MEMORANDUM

VILLAGE OF DEERFIELD

DATE: February 17, 2023

RE: RE: Prefiling Conference on Request for Approval of an Annexation, Rezoning, a Special Use for a Preliminary and Final Development Plan for an Industrial Planned Unit Development for Two Industrial Buildings; a Concept Plan for a Recreation Center/Field House, and Any Necessary Exceptions for the 101-Acre Property Located at 1 Baxter Parkway (located to the north of Horizon Therapeutics, and south of Parkway North Center on Saunders Road)

FIGURE 3.1: FUTURE LAND USE MAP

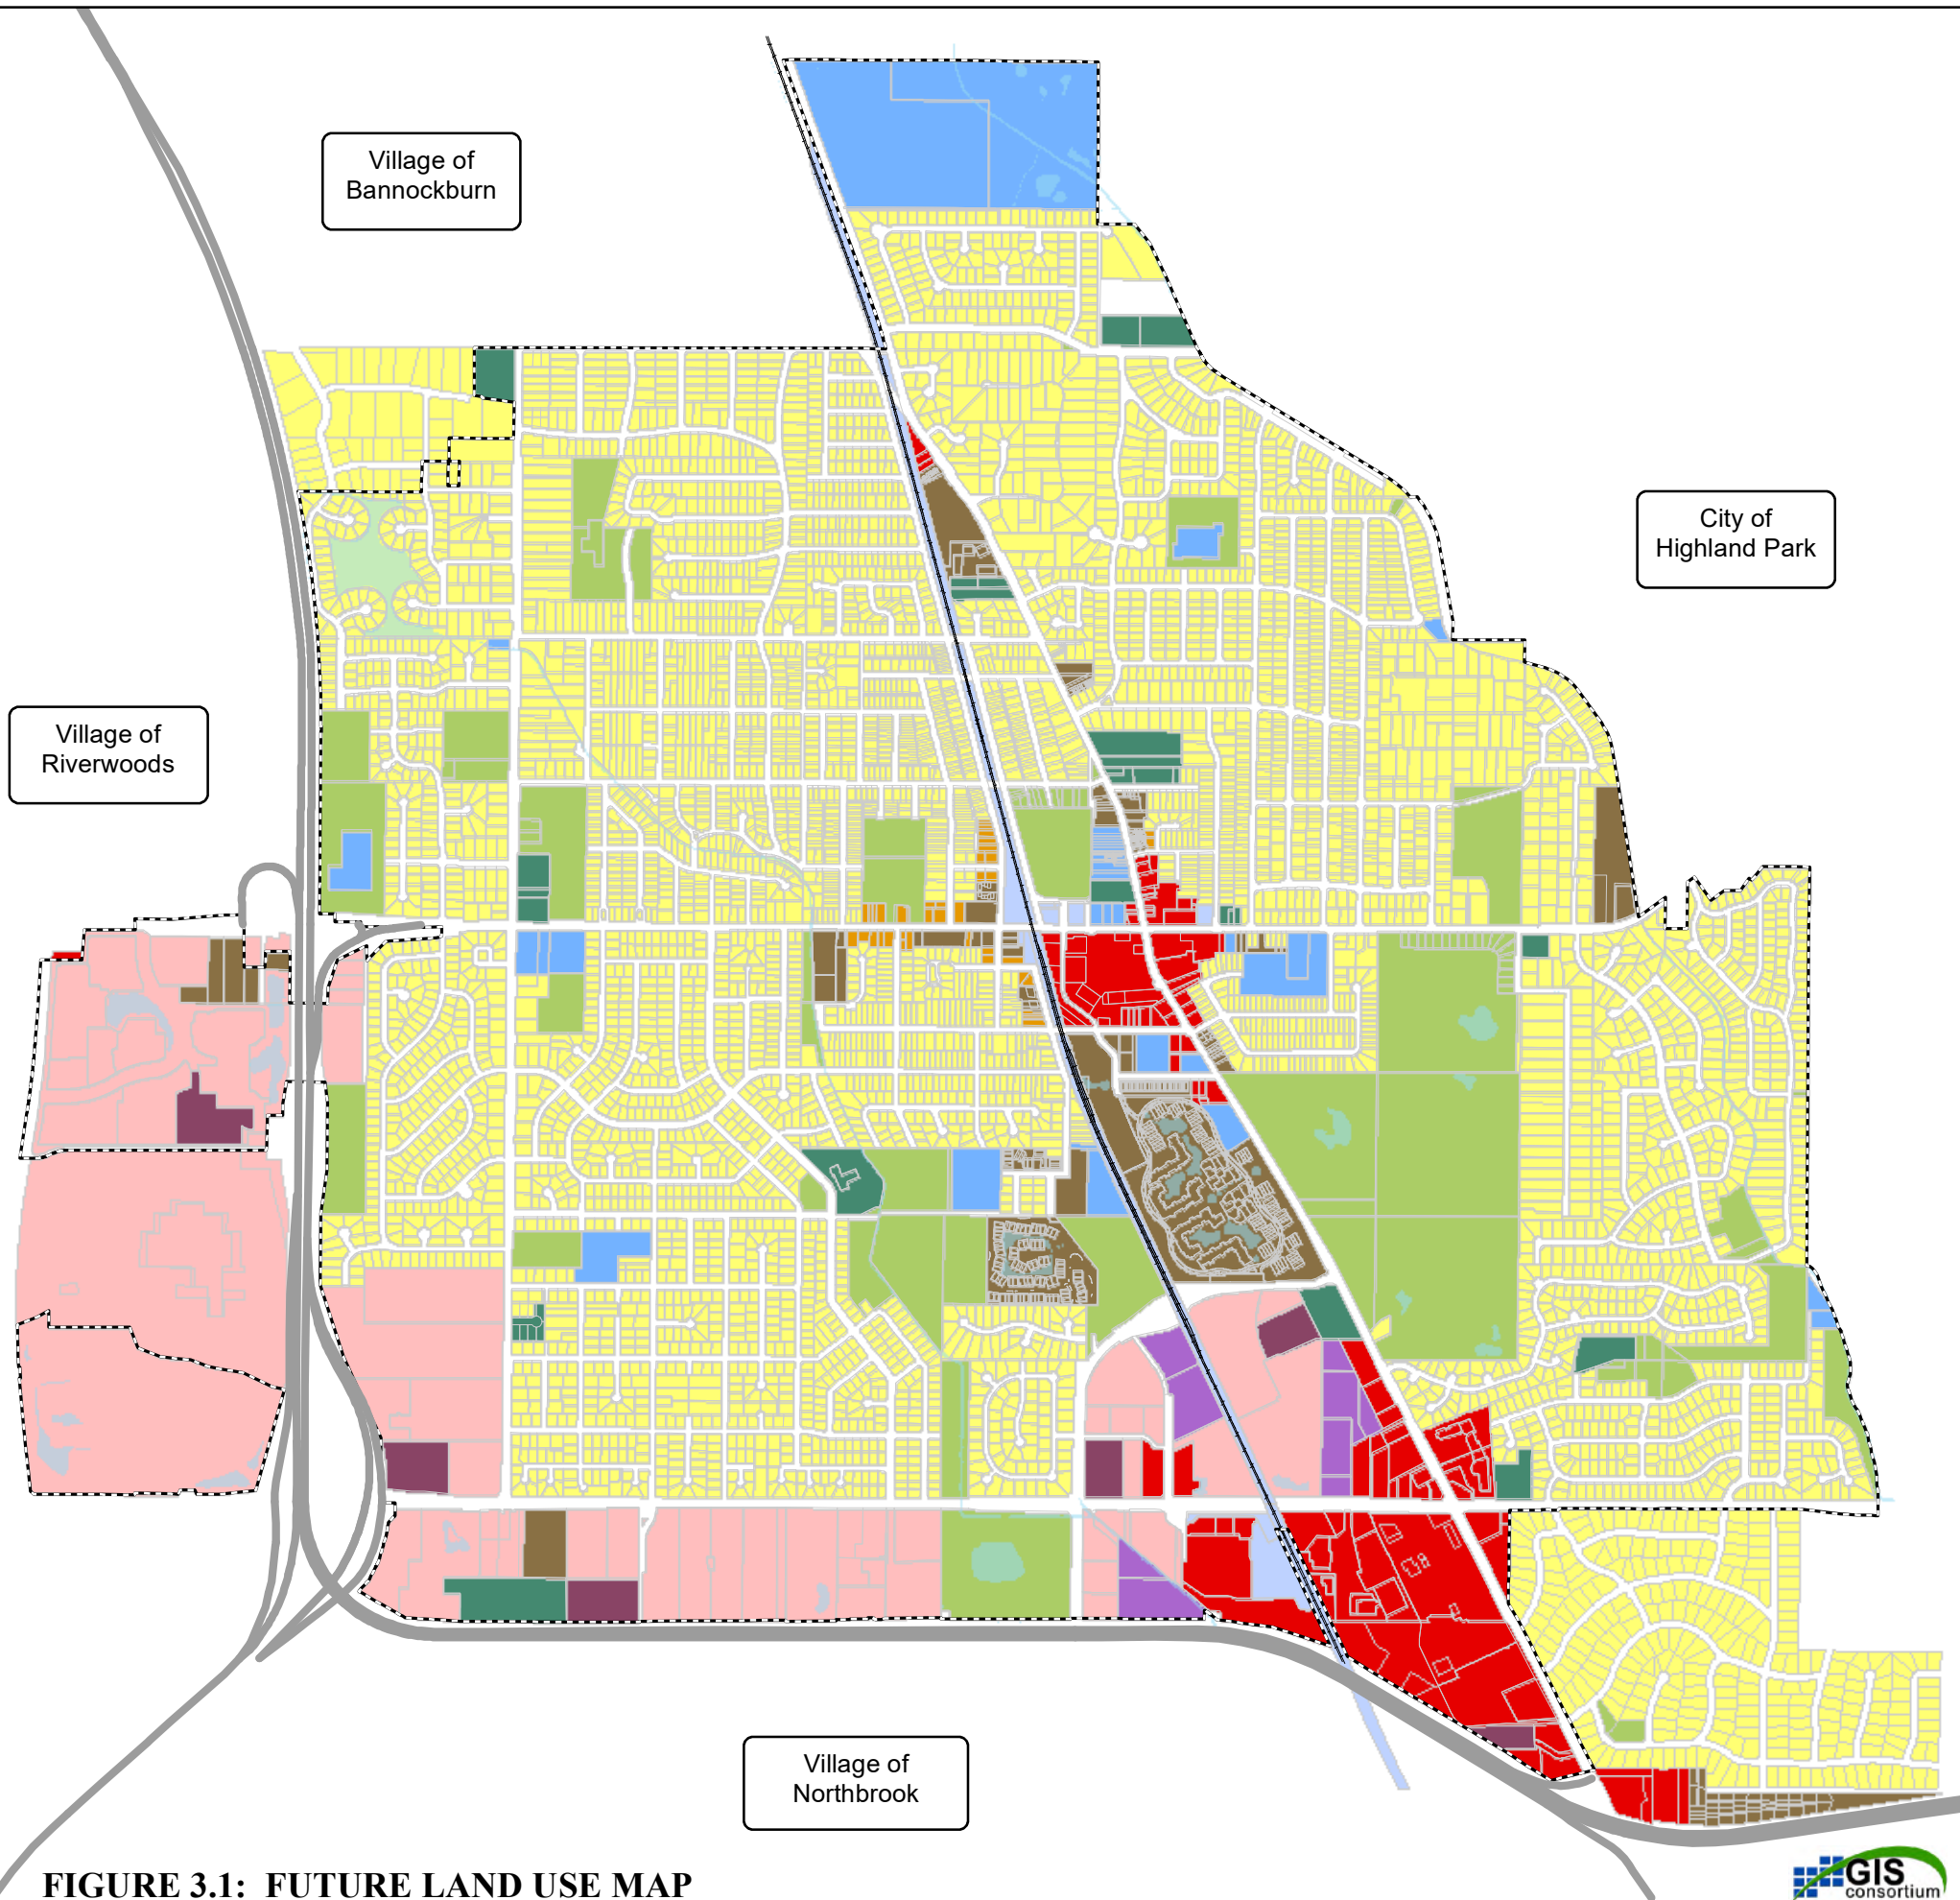
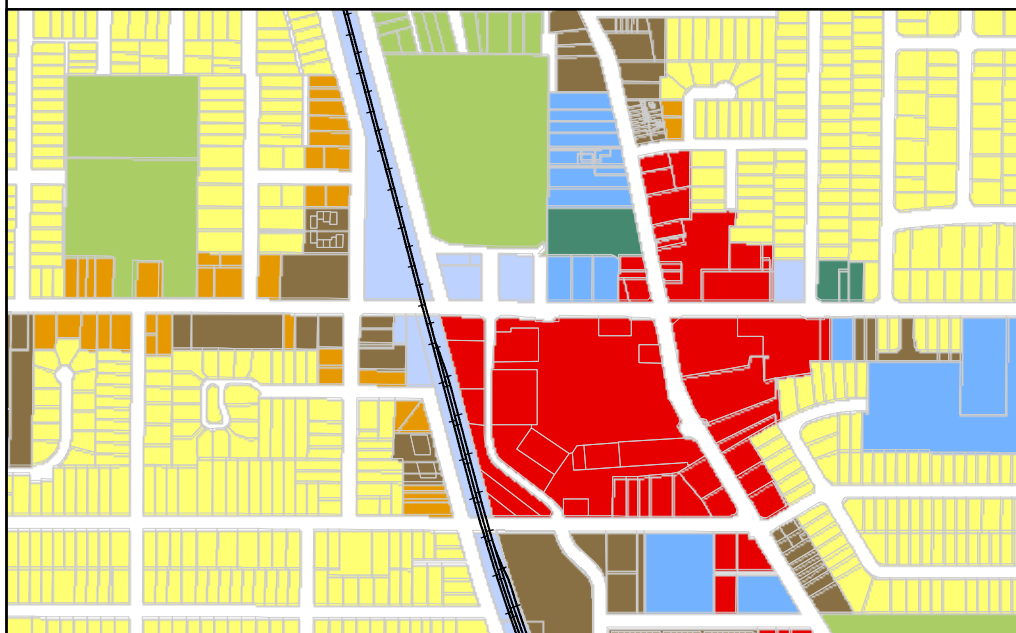
The Comprehensive Plan will need to be amended to change Figure 3.1 Future Land Use Map from Office to Industrial.
